UNITED STATES PATENT AND TRADEMARK OFFICE

APPLICATION NO.	FILING DATE	FIRST NAMED INVENTOR	ATTORNEY DOCKET NO.	CONFIRMATION NO.
10/721,616	11/24/2003	Seiji Sugiura	TOW-051	5616
959 7590 09/20/2007 LAHIVE & COCKFIELD, LLP ONE POST OFFICE SQUARE BOSTON, MA 02109-2127			EXAMINER LEWIS, BEN	
			ART UNIT 1745	PAPER NUMBER
			MAIL DATE 09/20/2007	DELIVERY MODE PAPER

Office Action Summary

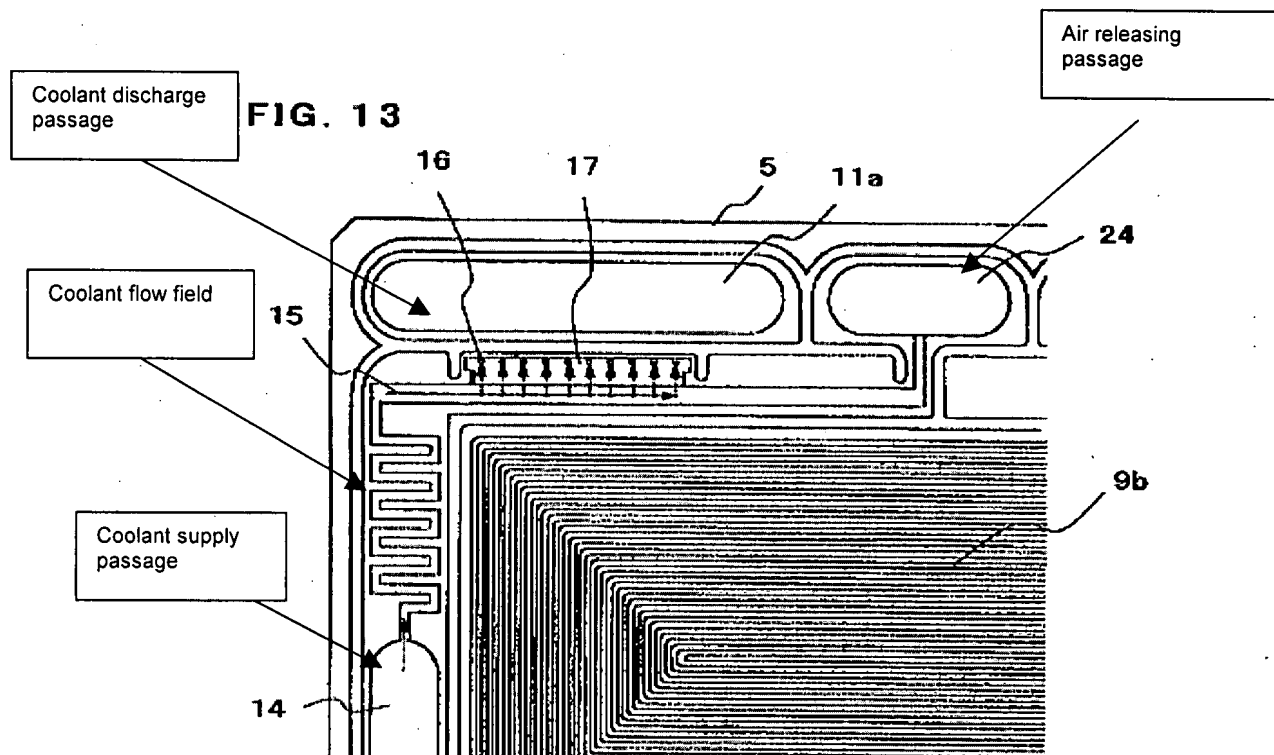
With respect to claims 1 and 4, Ogami et al disclose a polymer electrolyte fuel cell stack and method for operating the same and gas vent valve wherein fuel cell stack comprises membrane electrode assemblies (3) in which gas diffusion electrodes (2a, 2b) are arranged on both sides of an ion exchange membrane (1) and a reactant gas supply separators (5) interposed between the membrane electrode assemblies (3). The

reactant gas supply separators **(5)** each has a first surface having first reactant gas supply grooves **(9a)** for supplying first reactant gas, a second surface having second reactant gas supply grooves **(9b)** for supplying an second reactant gas, and water supply means for supplying water to the first reactant gas supply grooves **(9a)** (See abstract). Ogami et al also teach that the present invention is related to a polymer electrolyte fuel cell stack, and more specifically to a fuel cell stack structure for uniformly distributing mixed fluid of fuel gas and water "coolant" to each fuel cell unit in a polymer electrolyte fuel cell stack utilizing latent heat cooling with supply of water to reactant gas (Paragraph 003). FIG. 13 shows the gas vent hole **24** and its vicinity in the reactant gas supply separator **5**, seen from the oxidant gas supply surface. The gas vent hole **24** is connected to the buffer section **17**. As shown in FIG. 14, the fastening end plate **21** of the fuel cell stack **10** formed with the reactant gas supply separators **5** described above is equipped with and connected to a gas vent pipe **25**. A valve **26** is connected to the gas vent pipe **25** for selectively venting and blocking the gas vent holes **24** (Paragraph 0127). In the sixth embodiment described above, the valve **26** may be operated to open to communicate the gas vent holes **24** to the atmosphere when the water is supplied during the start-up operation of the fuel cell stack **10**, so that gas remained in the buffer sections **17** may be vented. Typically, water supply is stopped when the power generation by the fuel cell stack **10** is stopped. At that time, bubbles in the water passages to the communication holes **16** may be removed, because the water held below the communication holes **16** is remained there and the water supply manifold **14** is positioned below the buffer sections **17** (Paragraph 0128). On the other hand, the

water held above the communication holes **16** is drained through the communication holes **16** to the fuel gas supply grooves **9a**. In the sixth embodiment, the gas bubbles which may be present above the communication holes **16** can be fully vented in a short time by venting the residual gas in the buffer sections **17** through the gas vent holes **24** "air releasing passage" (Paragraph 0129) (See Fig. 13).

FIG. 6

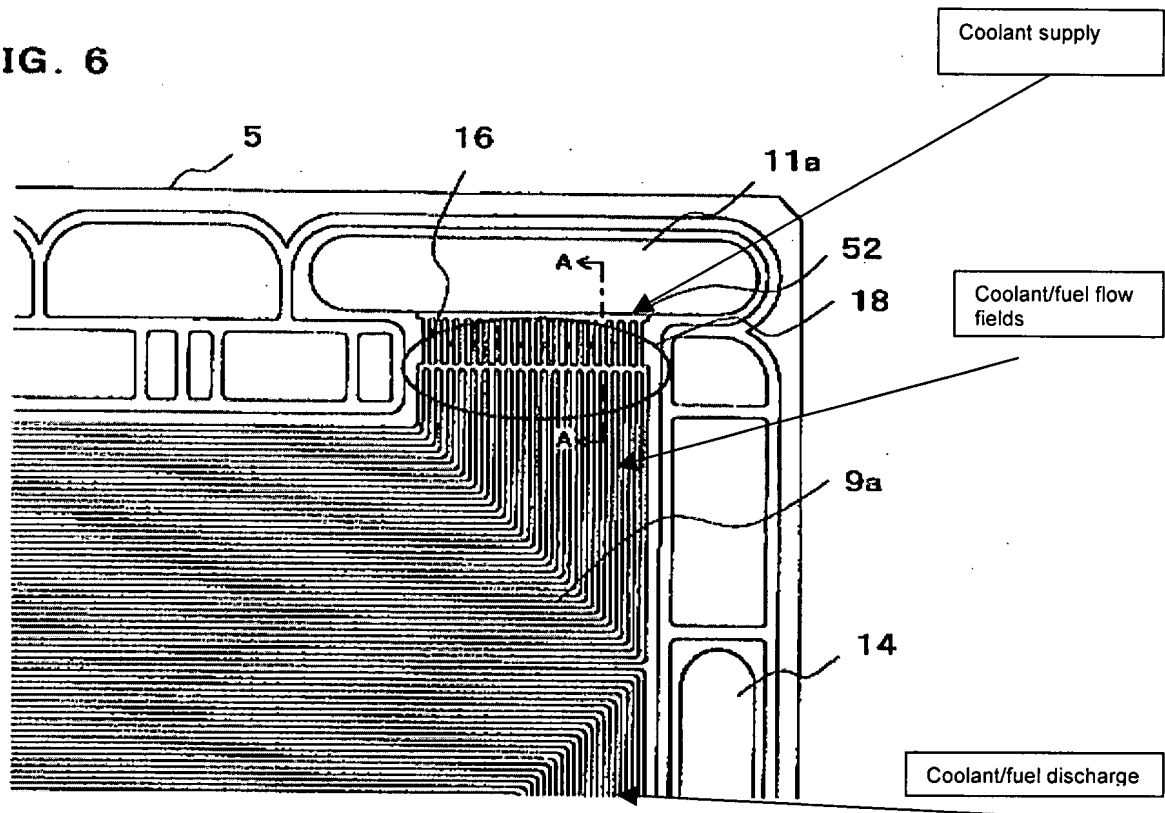
Also, it is noted that the fuel passages of Ogami et al. also function as coolant flow fields since the fuel passages contains both coolant and fuel. Since Ogami et al teach that the fuel gas branched from the fuel gas supply manifold 11a and the water branched from the water manifold 14 are mixed in the fuel gas introductory portion 18

and then flow through the fuel gas supply grooves 9a as two-phase flows (Paragraph 0092) (See Fig. 6).

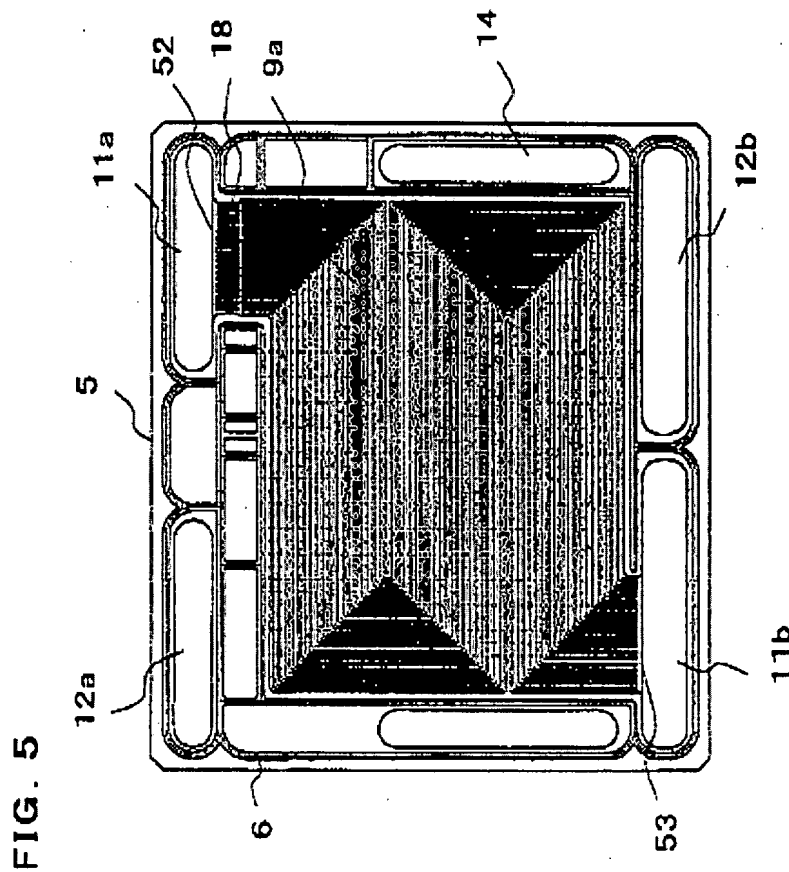
With respect to the coolant supply passage being provided at a middle position of one end of said separator and coolant discharge passage is provided at a middle position at the other end of said separator presents no novel or unexpected result over the location of the coolant supply and discharge passages in the Ogami et al. reference. The positioning of the coolant supply and discharge passages in lieu of those used in the references solves no stated problem and would be an obvious matter of design

choice within the skill of the art. In re Launder, 42 CCPA 886, 222 F.2d 371, 105 USPQ 446 (1955); Flour City Architectural Metals v. Alpana Aluminum Products, Inc., 454 F. 2d 98, 172 USPQ 341 (8th Cir. 1972); National Connector Corp. v. Malco Manufacturing Co., 392 F.2d 766. 157 USPQ 401 (8th Cir.) cert. denied, 393 U.S. 923, 159 USPQ 799 (1968).

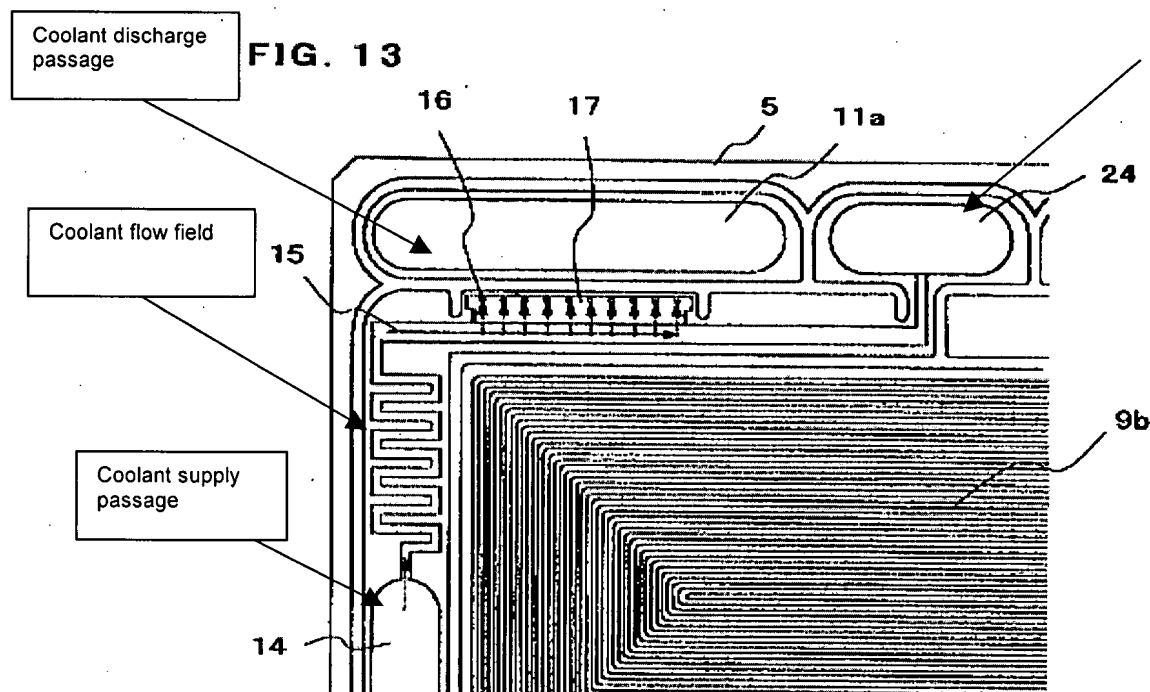
(b) Additionally, Applicants submit that the Ogami reference does not disclose the limitation that "said coolant supply passage is provided at a middle position of one vertical end of said separator, and said coolant discharge passage is provided at a middle position of the other vertical end of said separator," as recited in claim 1.

(c) Furthermore, Applicants submit that the Ogami reference does not disclose the limitation that "said separator includes first and second metal plates which are stacked together, and said coolant flow field is formed between said first and second metal plates," as recited in claim 4.

FIG. 6

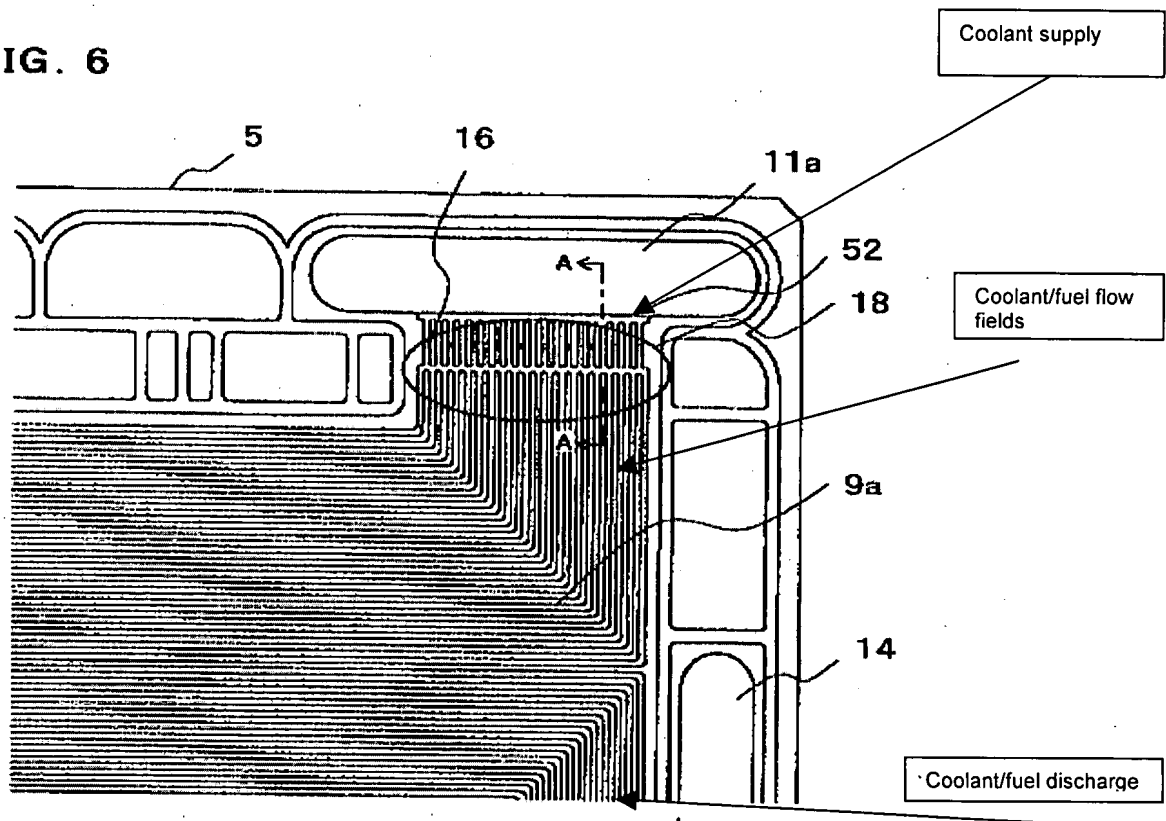
Also, it is noted that the fuel passages of Ogami et al. also function as coolant flow fields since the fuel passages contains both coolant and fuel. Since Ogami et al teach that the fuel gas branched from the fuel gas supply manifold 11a and the water branched from the water manifold 14 are mixed in the fuel gas introductory portion 18 and then flow through the fuel gas supply grooves 9a as two-phase flows (Paragraph 0092) (See Fig. 6).
